Memo

Mt Welcome FTAA Application

Statement of Experience

Scope of Memo

Constable Road, Wellington. – Path leaving carriageway

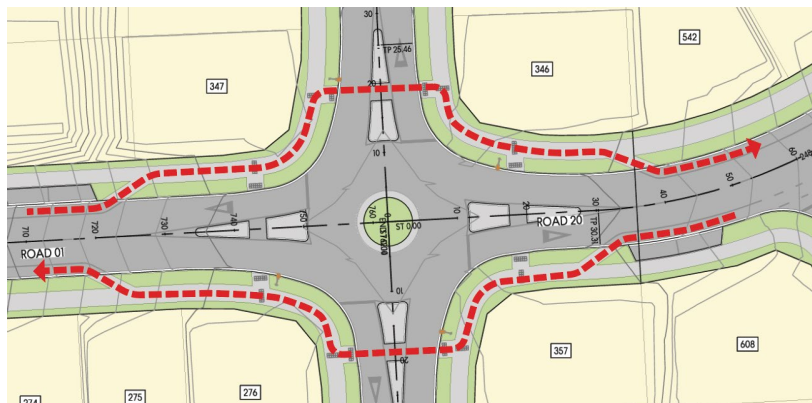
40. **Typical intersections/roundabouts:** All roundabouts are on Collector Roads. The Typical Intersections/Roundabouts drawing on page 27 of the Masterplan + Landscape Urban Design Strategy should show how the cycle lanes are integrated into the intersection. Appendix 30-20 PROPOSED ROADING LAYOUT PLAN shows the cycle lanes leaving the carriageway and moving onto the footpath utilising the same crossing point as the footpath before re-entering the carriageway. While I understand that this approach has been utilised elsewhere in the Wellington Region (e.g. Constable Road, see image below), the level of deviation required by a cyclist reduces the attractiveness of this route significantly and will often result in cyclists remaining in the carriageway through the intersection increasing uncertainty for drivers and pedestrians.

Route of cycle lane proposed through roundabouts – multiple changes of direction of travel and change of level.

RECOMMENDATIONS

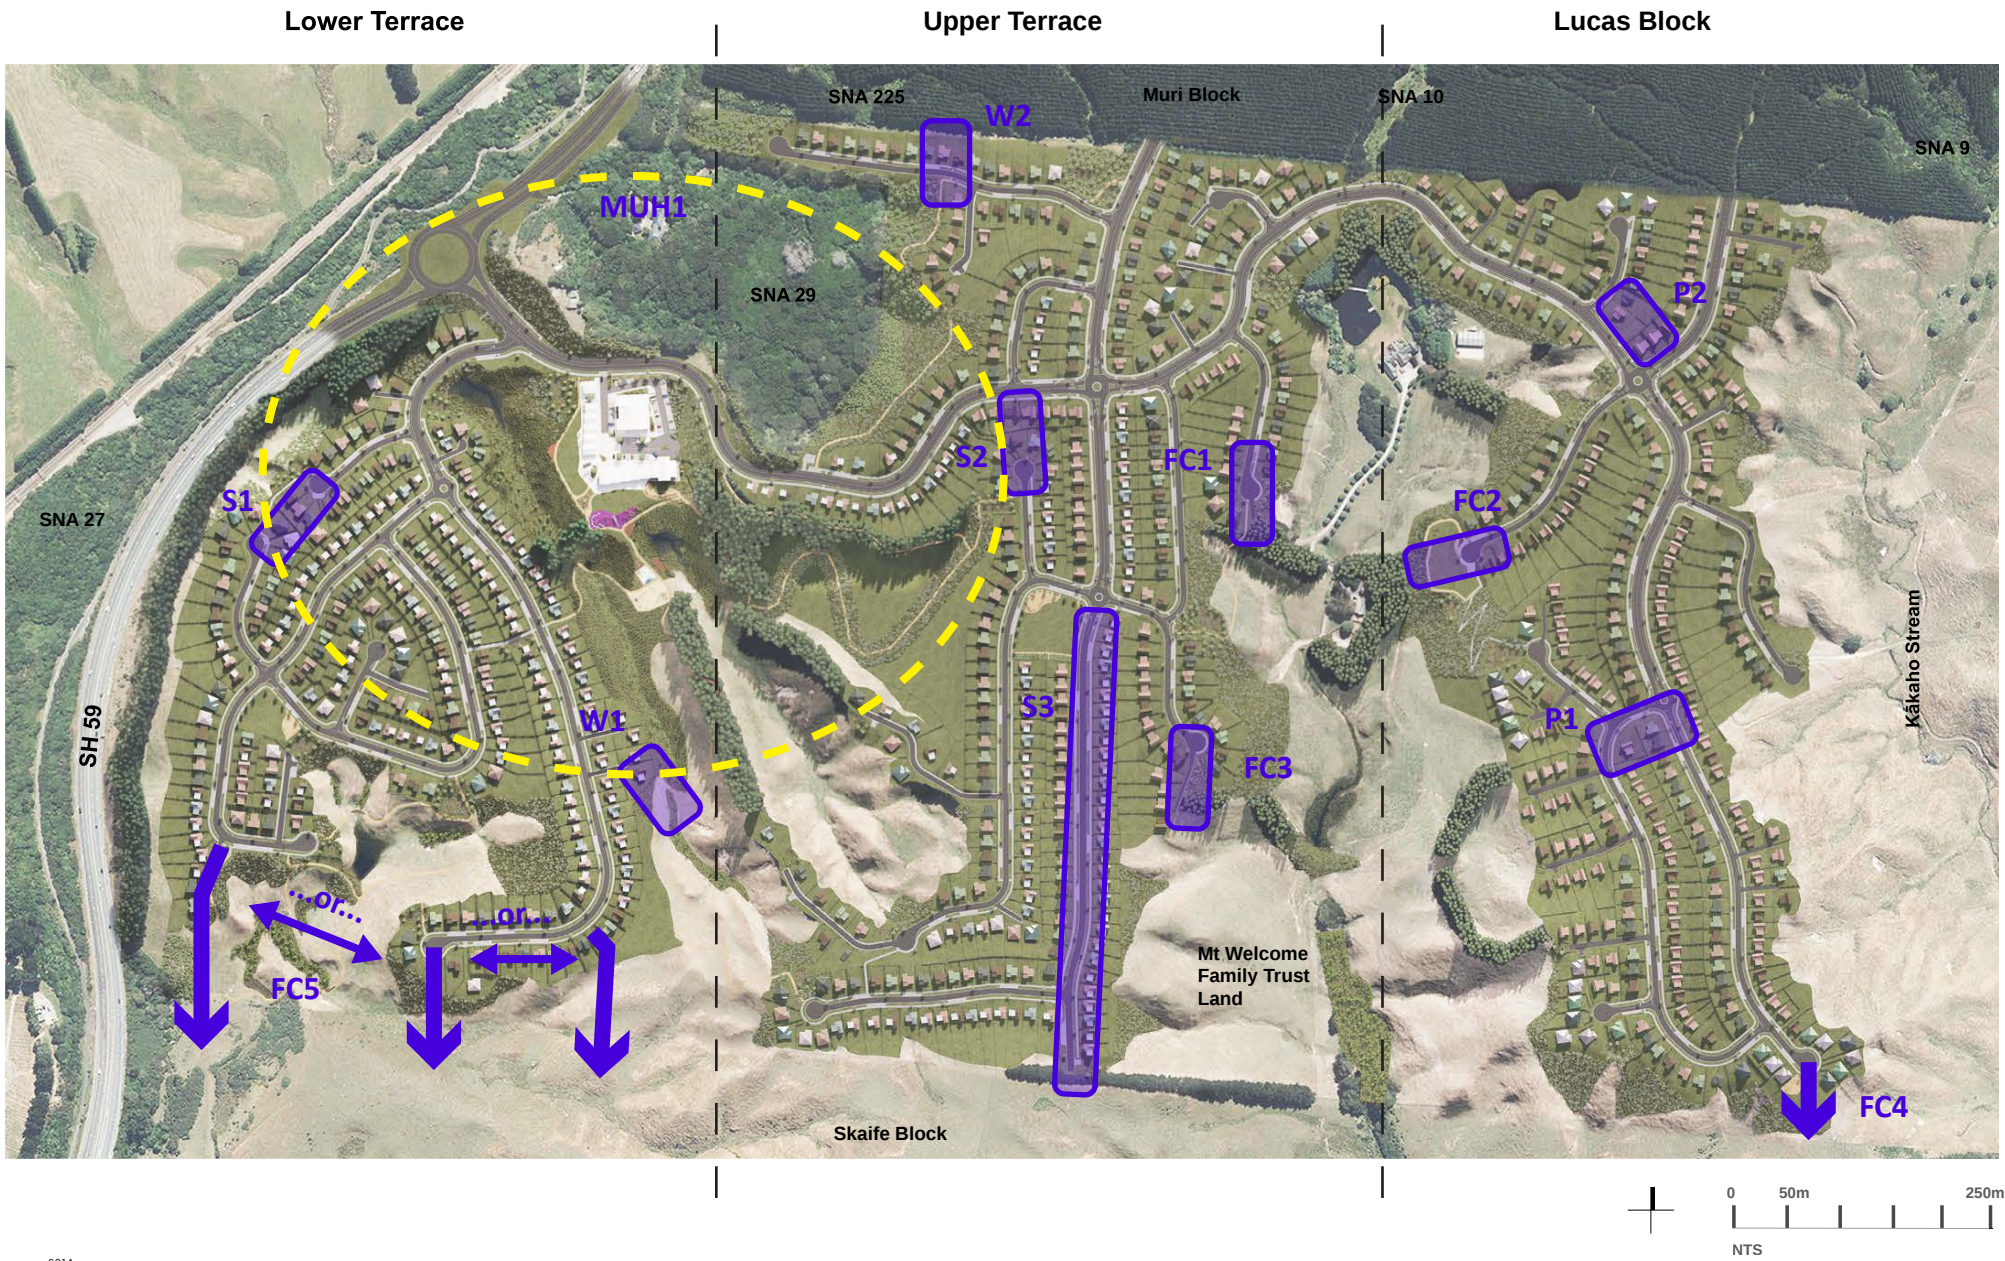
- S1:** Connect cul-de-sac heads
- S2:** extend street to connect with street to the north.
- Street connections are important for legibility and providing more convenient access for all modes on the local road network.
- S3:** Change 'collector road' type D-E to reflect type A-C including cycle paths
- This is the main north-south connector within the site and also the main connector between the Muri Block to the north and the Skaife block to the south, and is the only part of the main network without cycle lanes. This should be extended to contribute to the whole-of-area network.

- Ends of cul-de-sacs should be configured to allow future extension of street connections. Ensure size, shape and ownership of park at FC2 allows for connection. At FC5 provide for potential future street connection to the south.
- Essential to future-proof for extension of residential development both within and adjacent to the site. Allows compliance with the Northern Growth Area Structure Plan.

- P1, P2:** Locate these parks closer to the centre of the Lucas Block where they will be more readily accessible for residents on foot and add amenity and value to the more lots in close proximity.
- Also simplifies need to allow for future street connection FC2 & FC4 to the south.

The Network_

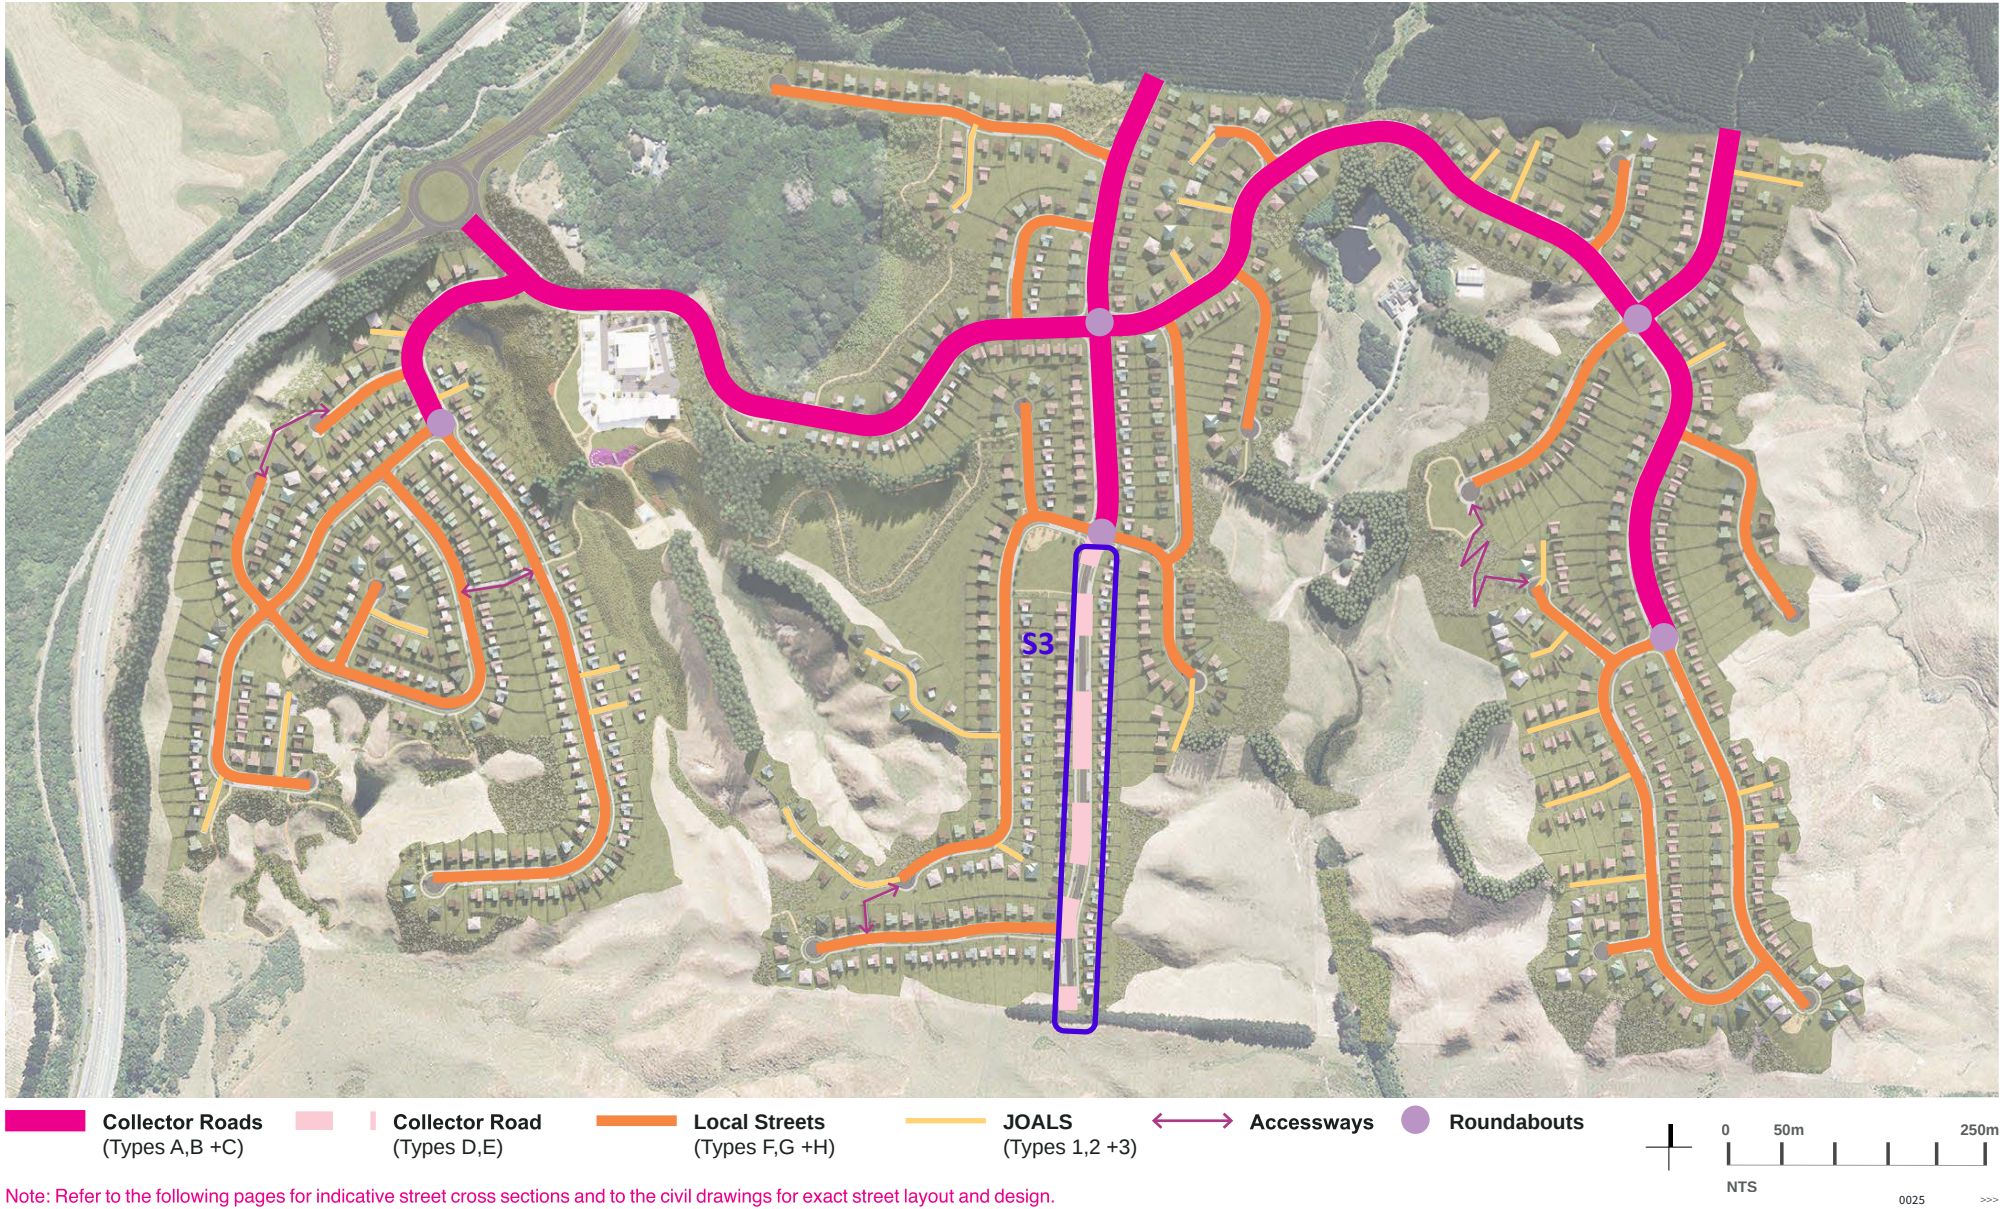
- W1:** Link Upper and Lower terraces with a short branch extension of the proposed trail. (Ref. Sk3.)
- Provides for recreational circuit and enhanced connectivity for keen walkers, and is an active-mode connectivity and amenity enhancement.
- W2:** Extend walking trail to the north into the Muri Block
- Provides for recreational and commuter connectivity to the north that is not currently provided for. Closer alignment with the structure plan.

- MUH1:** consider strategy to facilitate multi-unit housing (of more than 3 units per lot) in the area within a reasonable walkable catchment of the local centre.
- Positive response to District Plan intentions and provide for housing diversity.

- S3:** Change status of ‘Local Street’ to ‘Collector Road’
- *This is a main connector between the Muri Block to the north and the Scaife block to the south, and is the only part of the main network without cycle lanes. This should be extended to address the network.*

The Network_

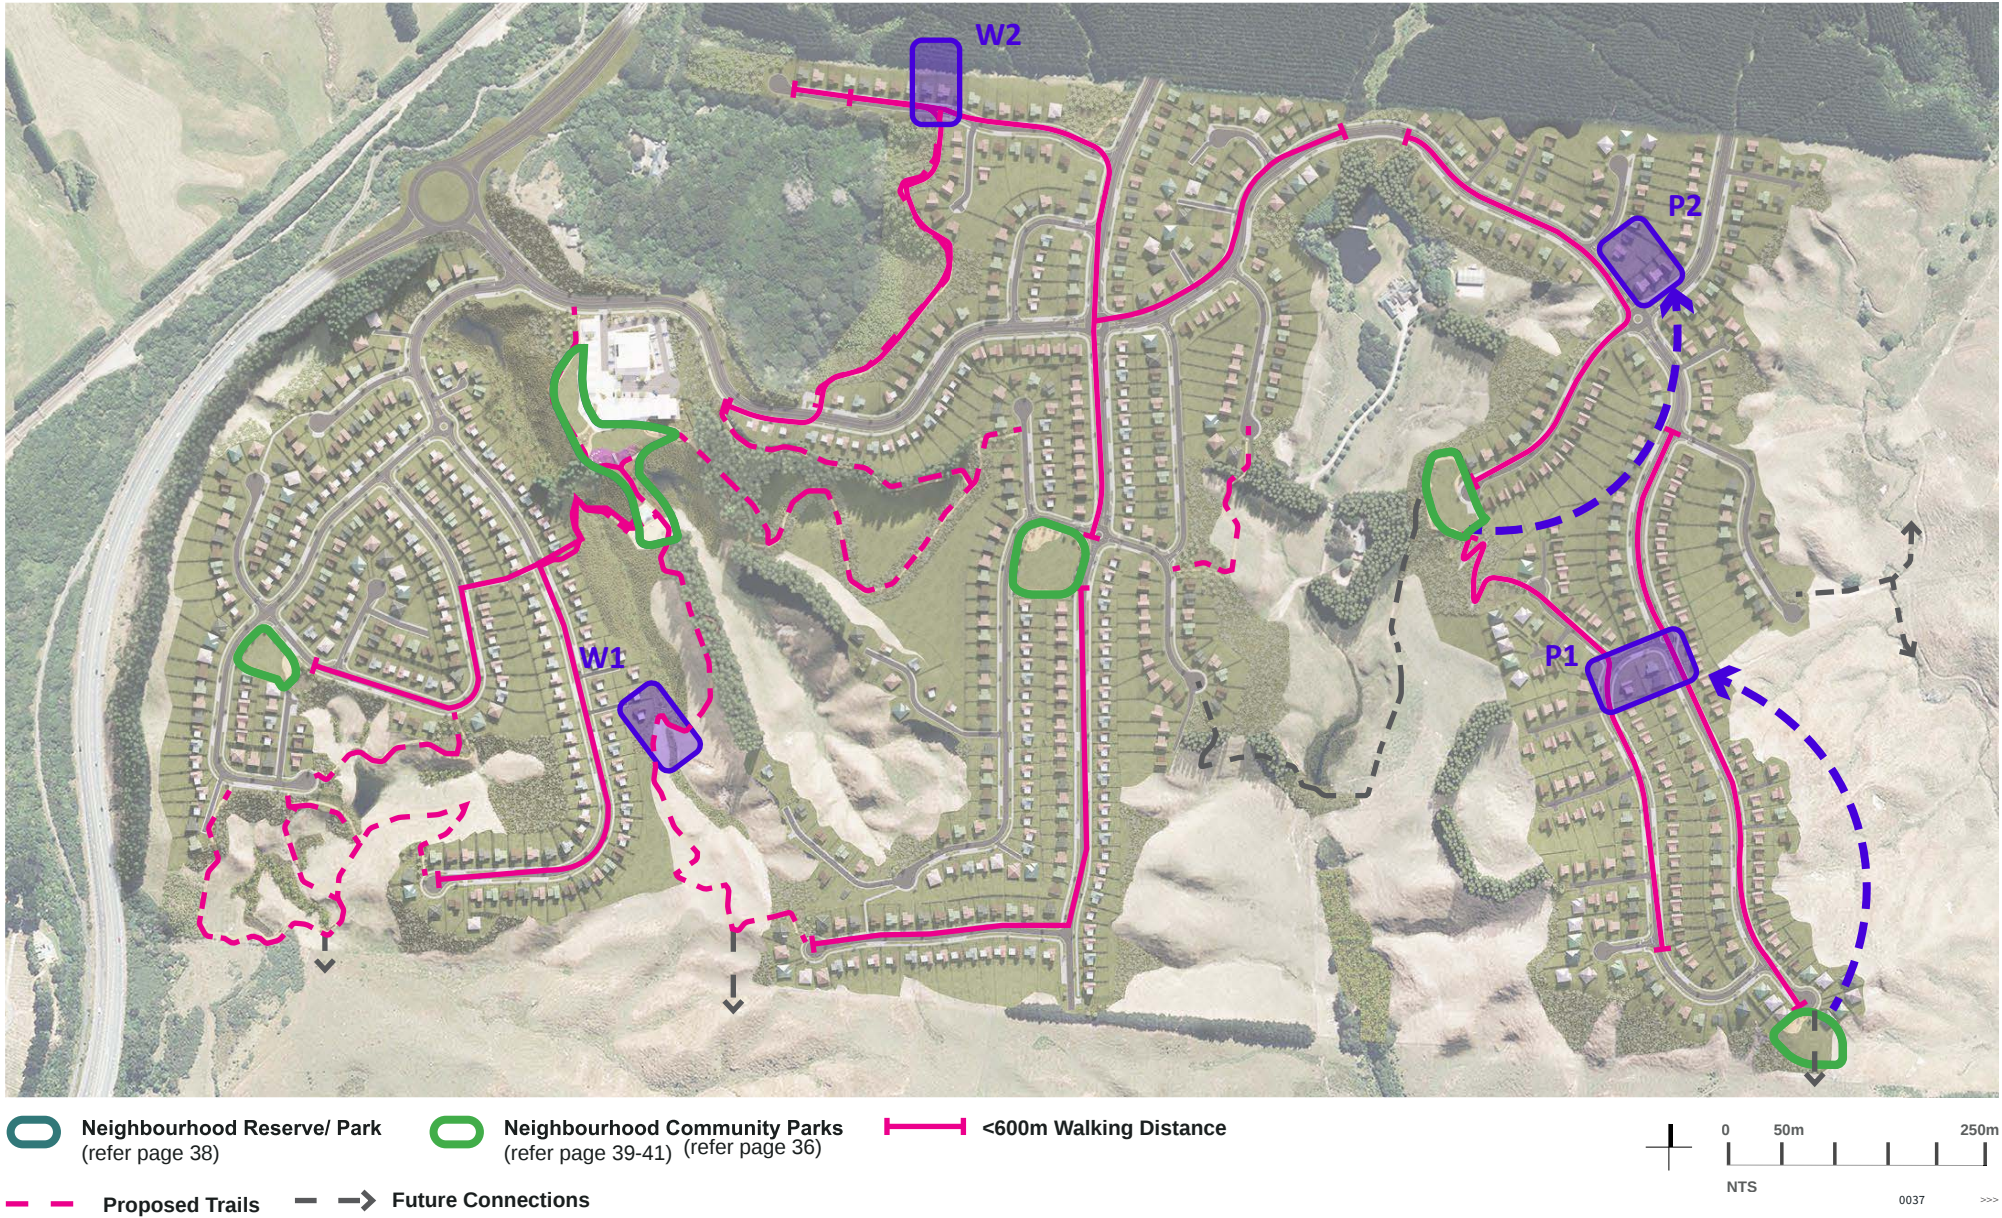
P1: Locate this park closer to the centre of the Lucas Block where it will be more readily accessible for residents on foot and add amenity and value to the more lots that will be close to it.

- Also simplifies need to allow for future street connection FC4 to the south through a proposed park.

P2: With relocation of P1, locate this park closer to the main road access where it will be more readily accessible for residents on foot and add amenity and value to the more lots that will be close to it.

- Also simplifies need to allow for future street connection FC2 for future development.

W1: Link Upper and Lower terraces with a short branch extension of the proposed trail.

W2: Extend walking trail to the north into the Muri Block
